# R5

## 750cc

### PrintArea

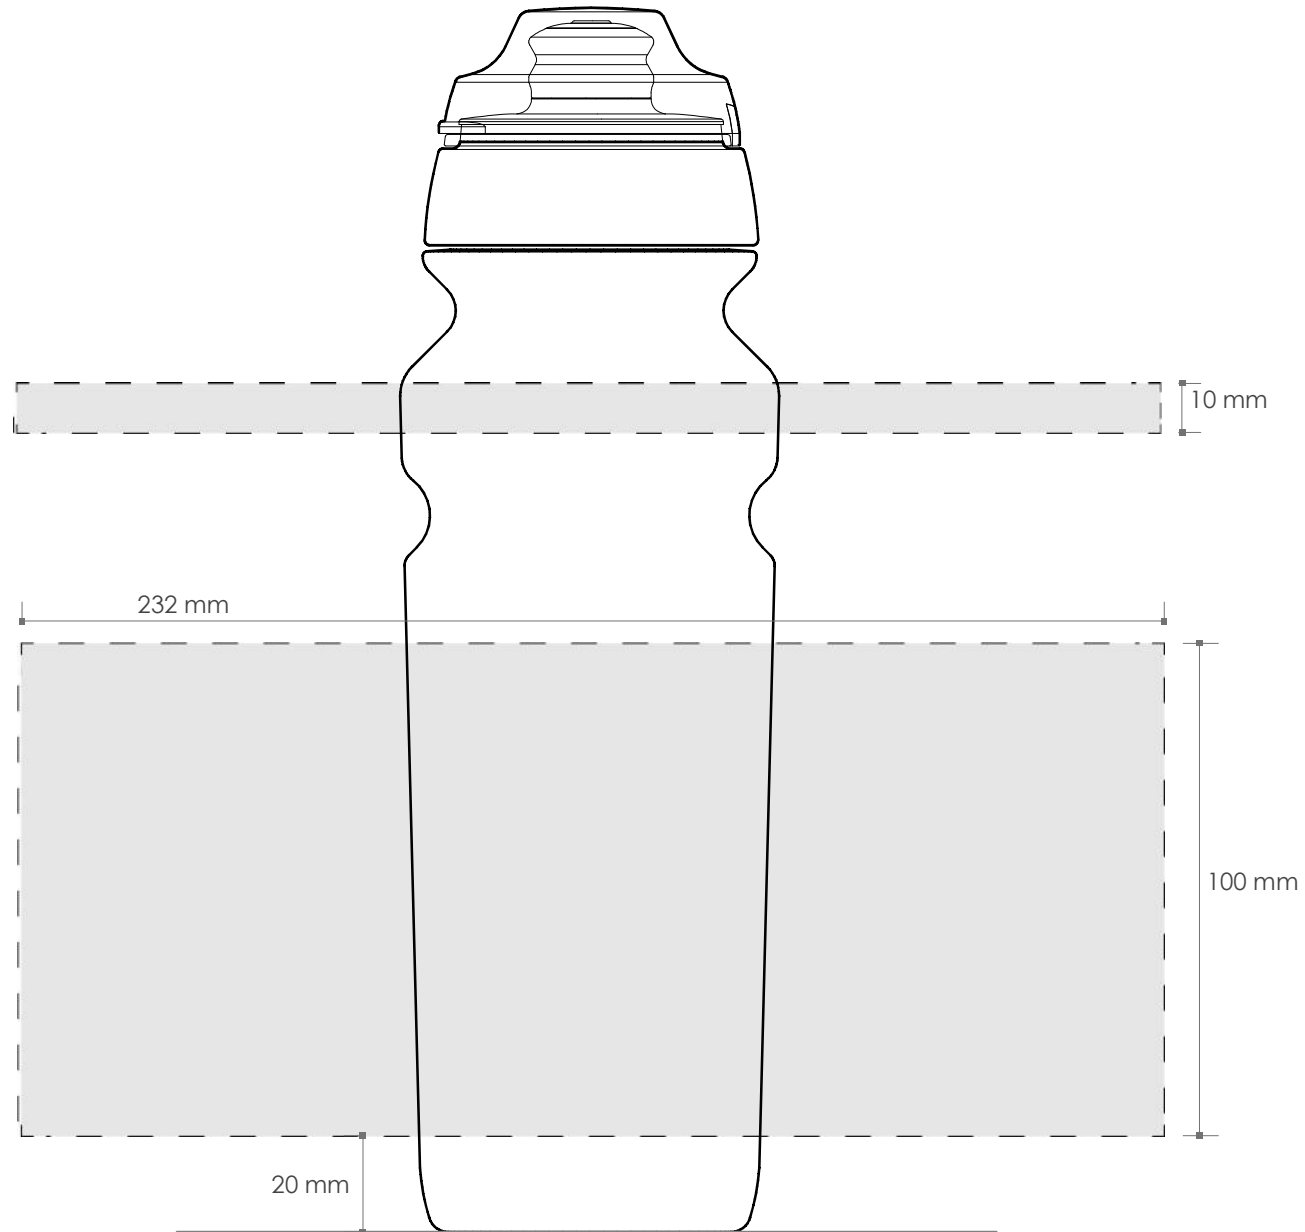
The impression can not close on the circumference of the bottle:  
it's necessary to consider a non-printable area (approx. 0,8 cm width)
